February 15, 2016

ND-16-0083
10 CFR 50.90

Southern Nuclear Operating Company
Vogtle Electric Generating Plant Units 3 and 4
Request for License Amendment:
Update of Common Qualified (Common Q) Platform
Software Program Manual and Topical Report (LAR-15-017)

Figure 3-1 Development Process

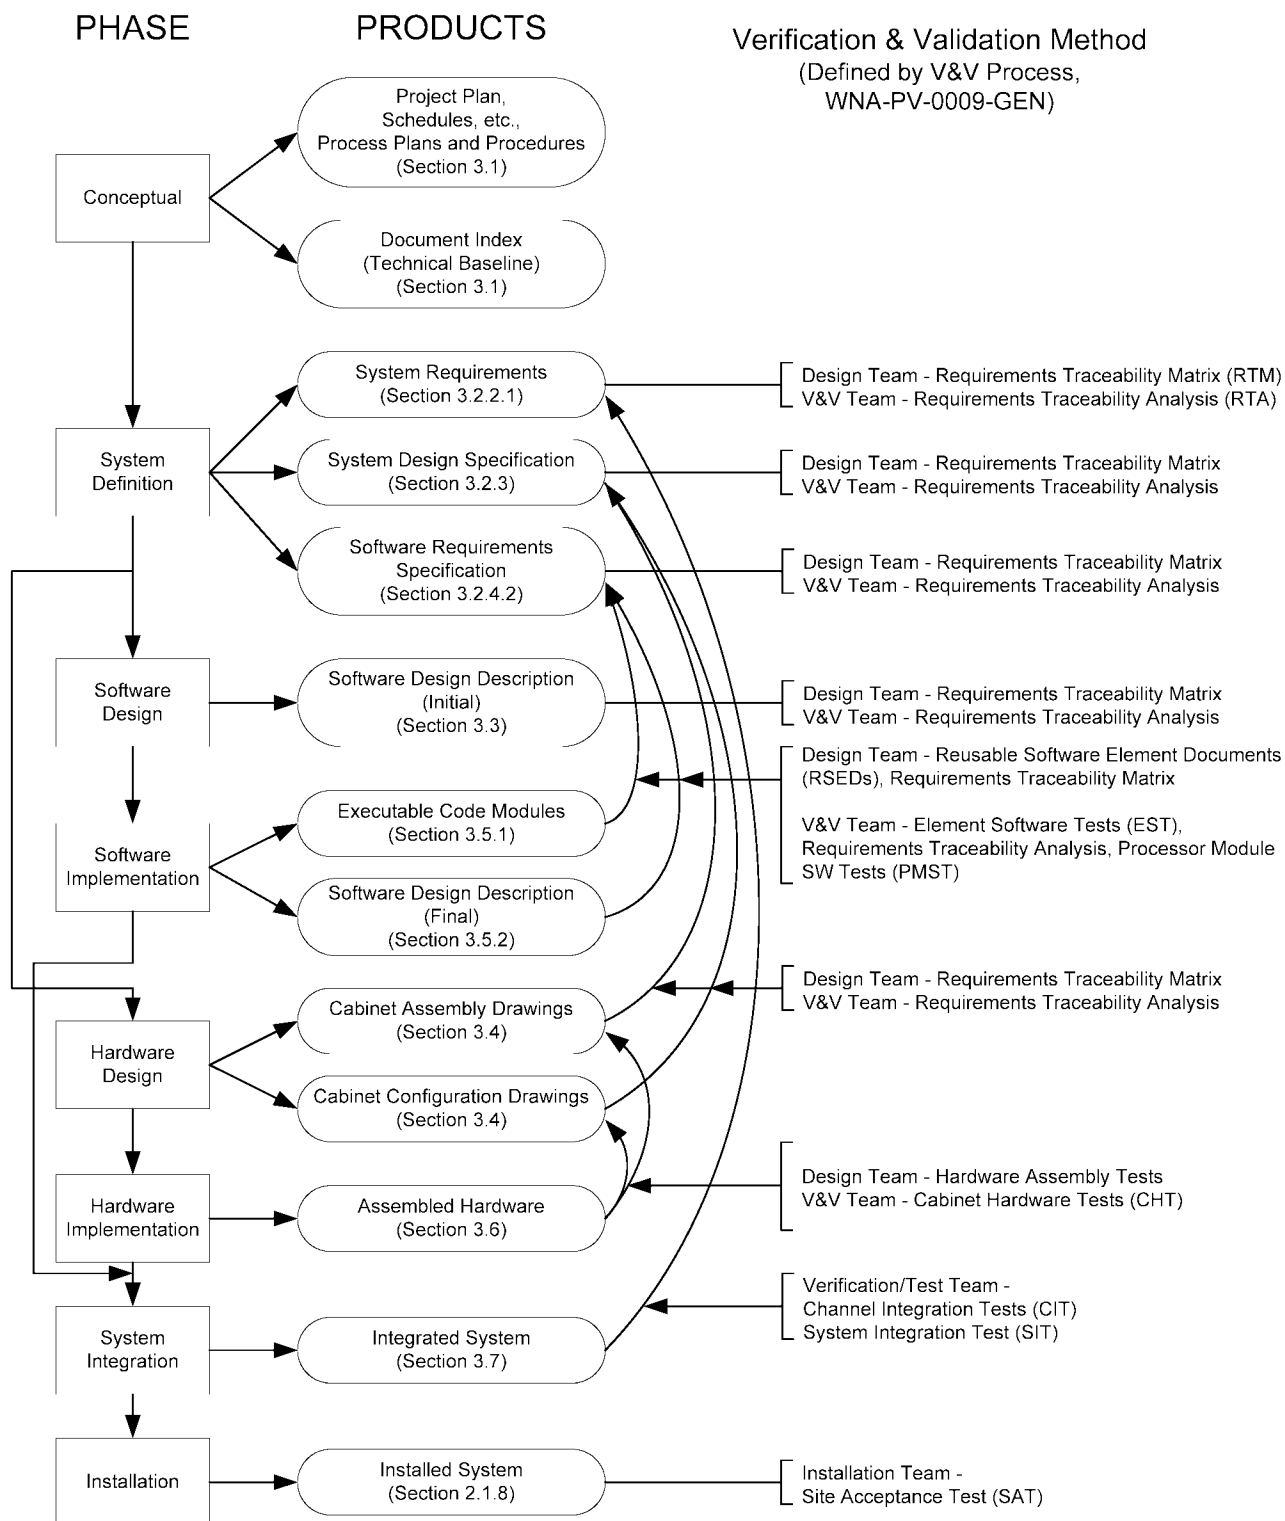
2	Warren R. Odess-Gillett	Changes are Class 3 as per NSNP 3.4.1. Updated Figure 3-1 per RAI response RAI-SRP 7.1-ICE-10, reference the SPM for the operation, maintenance and retirement software life cycle phases, and technical editing changes	6/3/09
3	Warren R. Odess-Gillett	<p>Updated to reference the newly NRC-approved Common Q™ Topical Report (WCAP-16097-P-A, Rev. 3).</p> <p>Updated to reference the newly NRC-approved Software Program Manual for Common Q Systems (WCAP-16096-P-A, Rev. 4).</p> <p>Updated Section 3.1 to remove the term Document Index.</p>	4/10/13
4	Matthew A. Shakun	<p>The following change was made to address APP-GW-GEE-4380 and CAPAL 100320452:</p> <ul style="list-style-type: none"> Updated to include alternate processes to WCAP-16096-P-A, Rev. 4, "Software Program Manual for Common Q™ Systems" and WCAP-16097-P-A, Rev. 3, "Common Qualified Platform Topical Report" 	See EDMS
